| <b>Well Name:</b> SD WE 15 FED P9           | <b>Well Location:</b> T26S / R32E / SEC 15 / SESE / 32.035506 / -103.658395 | <b>County or Parish/State:</b> LEA / NM |
| <b>US Well Number:</b> 3002543641           | <b>Operator:</b> CHEVRON USA INCORPORATED                                   |   |

**Subsequent Report**

**Type of Action:** Plug and Abandonment

As Plugged

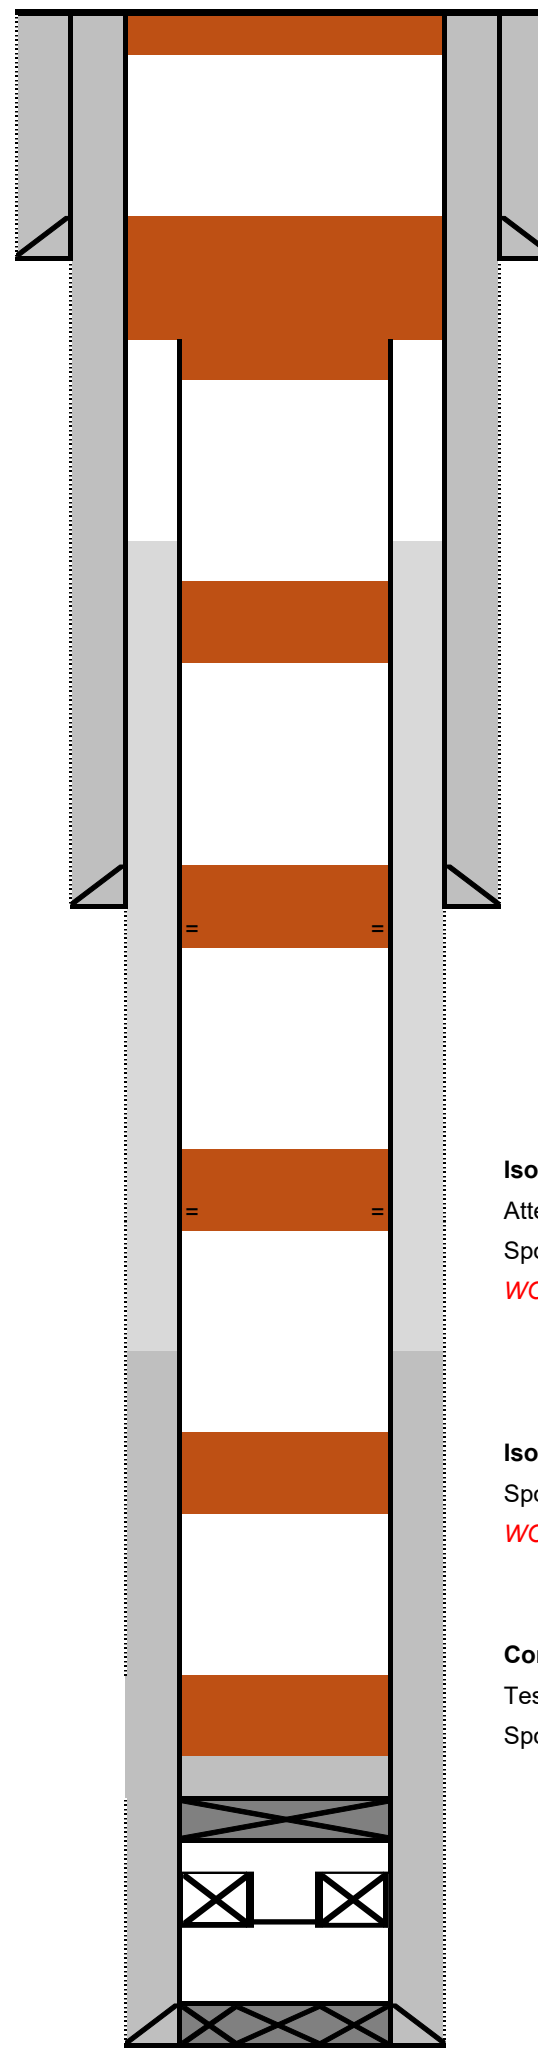
**Isolate Fresh Water (WSEA 10-E)**  
 Spot 127sx Class C f/ 300' -0'

**Isolate Surface Casing Shoe/Top Salt/Stump Plug (WSEA 10-D)**  
 Spot 200sx Class C f/ 1100 -445'  
 WOC/Tag Plug @460'

**Cut Casing @ +/- 1050'**  
 Circulate backside clean (WSEA 6-A & 10-F)  
 Pull Casing out of well & LD

**Spot spacer plug per COA**  
 Spot 30sx Class C f/ 2,763' -2446'  
 Spot and Go

**Isolate Base Salt/Lamar/Bell Canyon (WSEA 10-C)**  
 Attempted to Perf/No Injection @ 4630'  
 Spotted 45sx Class C f/ 4,680' -4,200'  
 WOC Tag plug @ 4186'

**Isolate Cherry Canyon**  
 Attempted to Perf/No Injection @ 5560'  
 Spotted 40sx Class C f/ 5,610' -5,187'  
 WOC Tag plug @ 5248'

**Isolate Brushy Canyon**  
 Spot 40sx Class H f/ 7,175' -6,797'  
 WOC Tag plug @6805'

**Confrim Tubing Tag @ 8534' (WSEA 10-B)**  
 Tested casing 500psi for 30 min held no leakoff  
 Spot Upgrade 30sx CI H f/ 8534-8250
